RE: 17TH STREET CANAL PARALLEL FLOOD PROTECTION
PHASE 1B - HAMMOND HIGHWAY TO SOUTHERN RAILWAY
OLB PROJECT NO. 2043-0207

In your letter of October 21, 1988, you listed comments on our preliminary plans for the above referenced project. In our review of those comments, we discovered that the slope stability calculations for the first six reaches of this project do not properly reflect the actual factors of safety.

We are submitting revised slope stability and sheet pile analyses for Reaches 1 through 6 which supersede the previously submitted calculations and consequently make obsolete comments "a" and "b" of your letter of October 21, 1988.

REACH 4
STA. 614+00 TO STA. 625+00

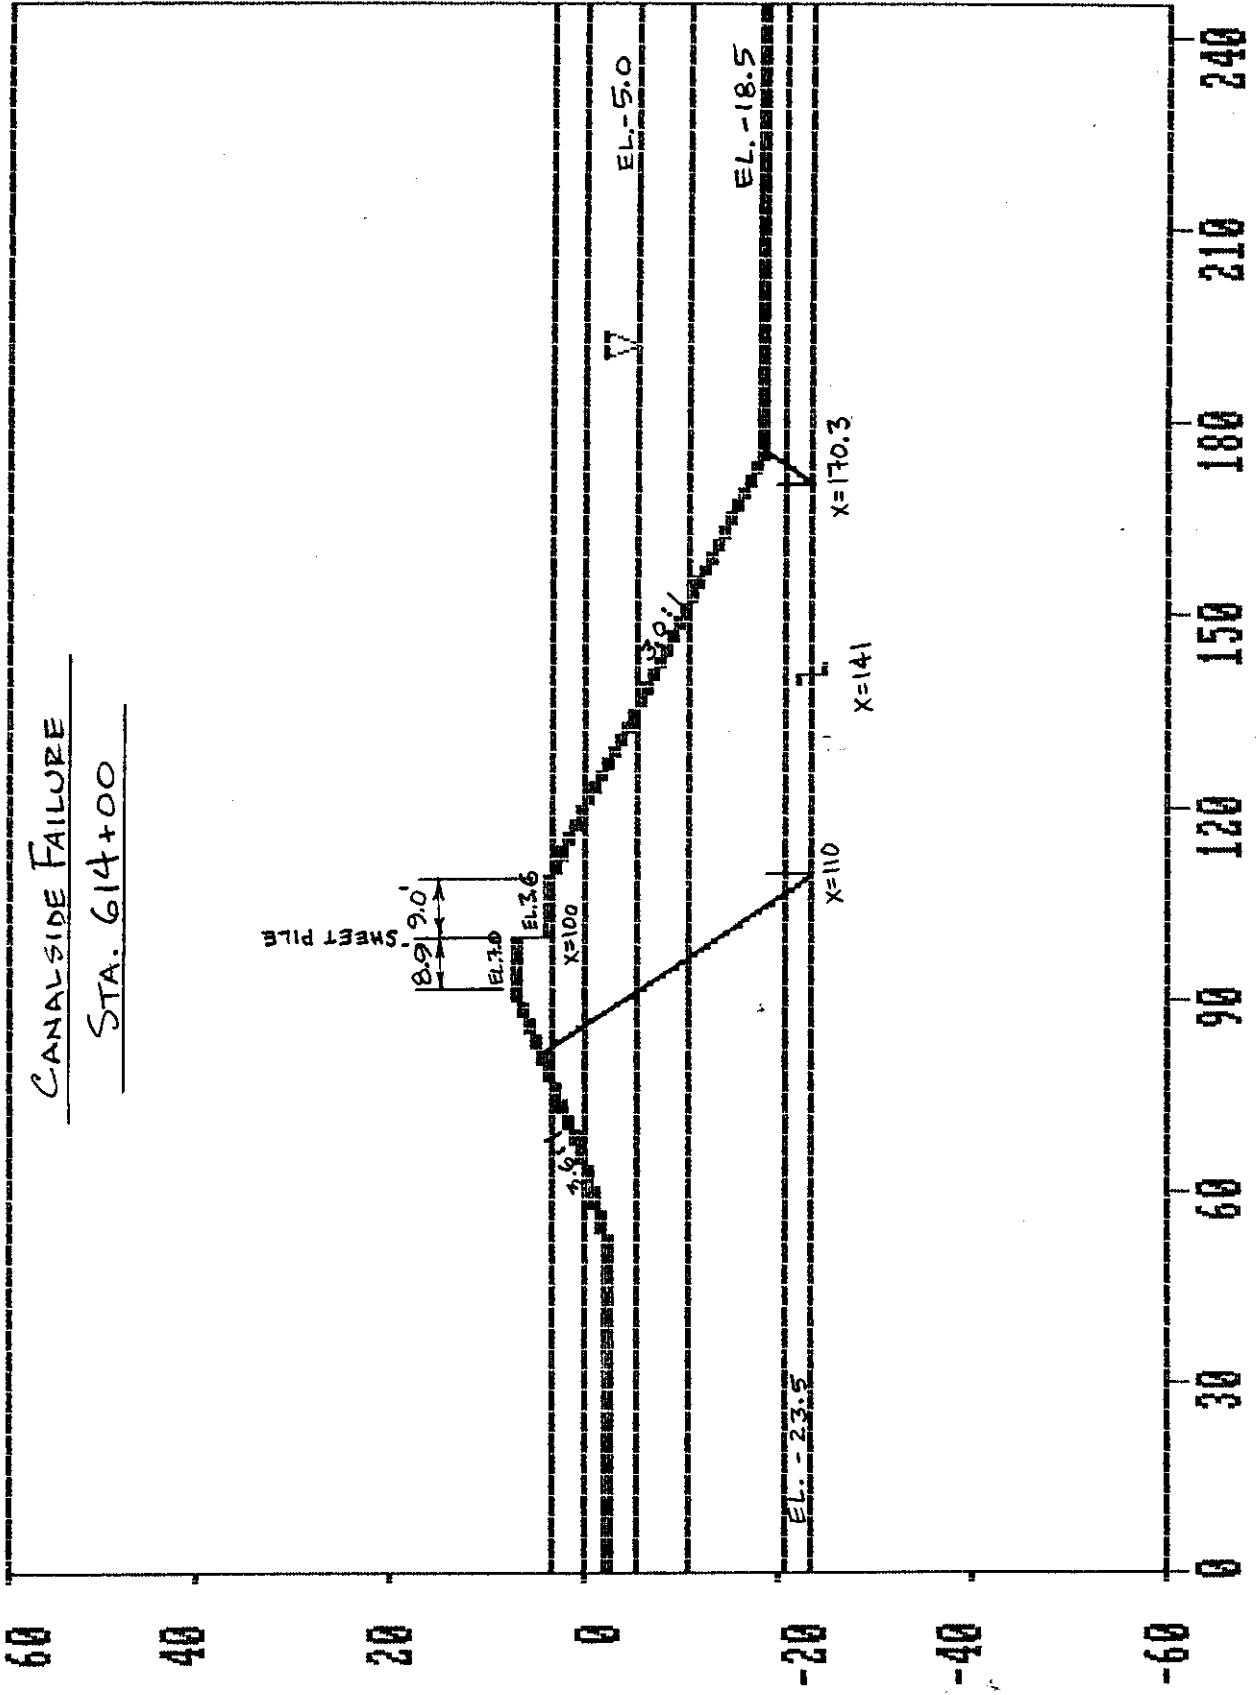
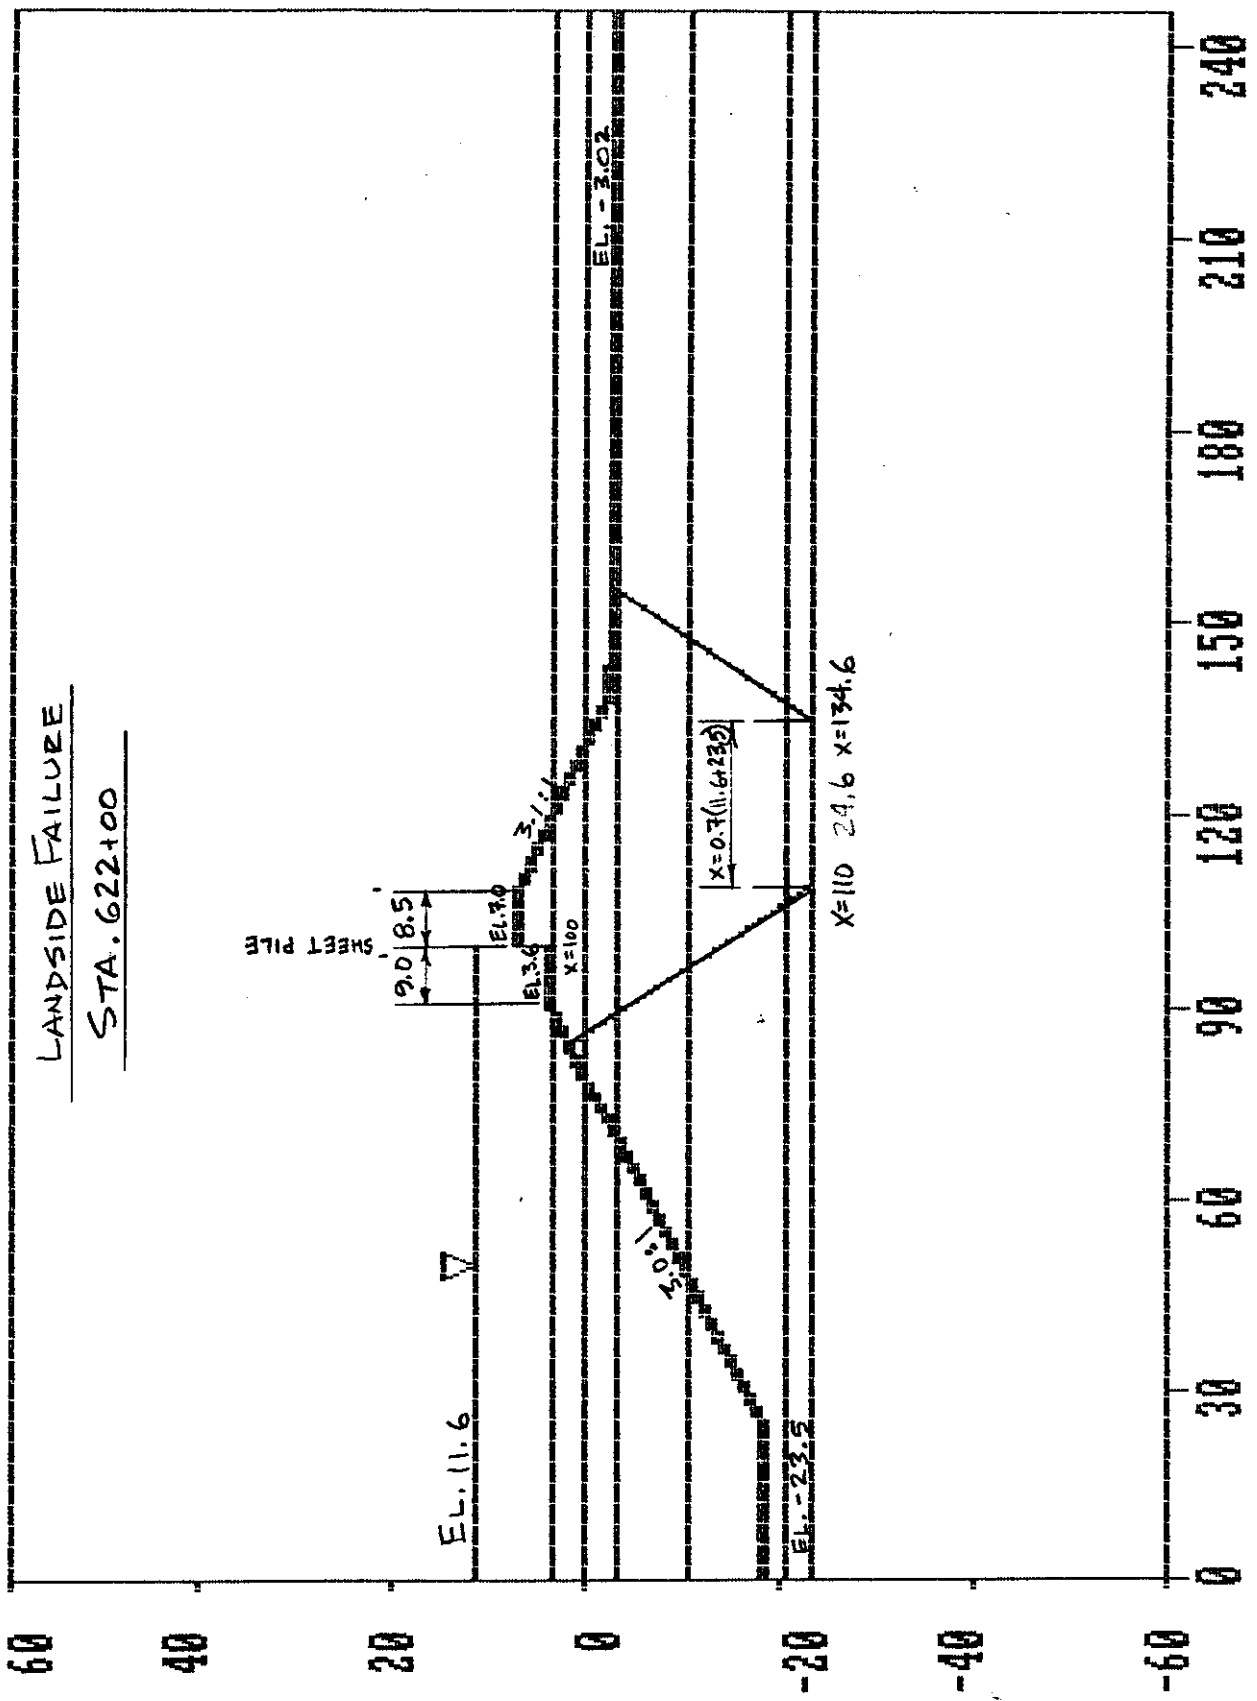
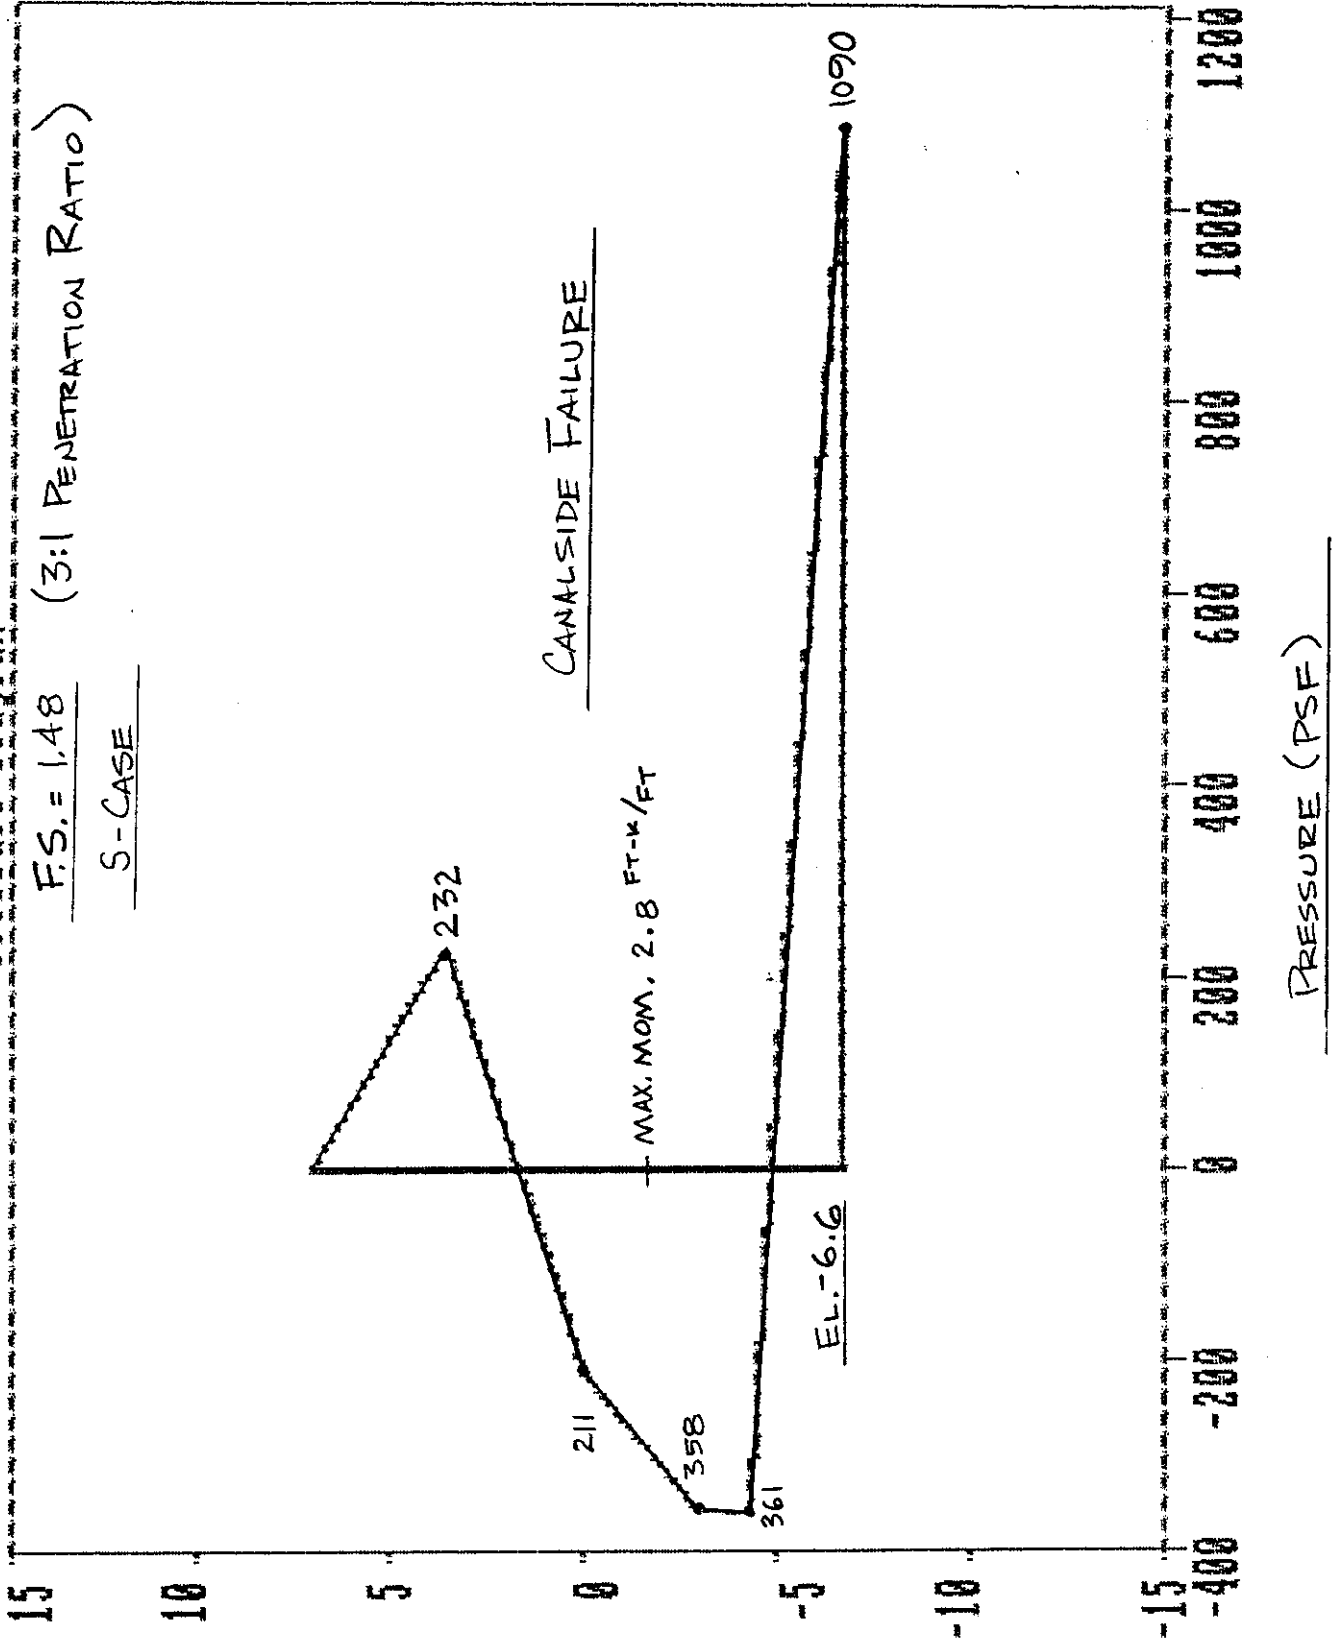
Revisions to Cross-Section : Realign Sheet Pile
Decrease Step Width to 9.0' (Hold Elevation at 3.6)

GDM Tip @ -6.8 8' crown width

Canalside Failure - 614+00 and 616+00. The section at Sta. 614+00 governs.
*** Minimum Factor of Safety = 1.32 ***

Landside Failure - 616+00, 618+00, 620+00, 622+00 and 624+27. The section at Sta. 622+00 governs.
*** Minimum Factor of Safety = 1.30 ***

Required Penetration : -6.6 (Canalside Failure 3:1 Ratio; S-Case F.S.=1.48)
Design Bending Moment : 2.8 Ft-K/Ft @ EL. -1.7 (Canalside Failure 3:1 Ratio; S-Case F.S.=1.48)
Maximum Deflection : In.
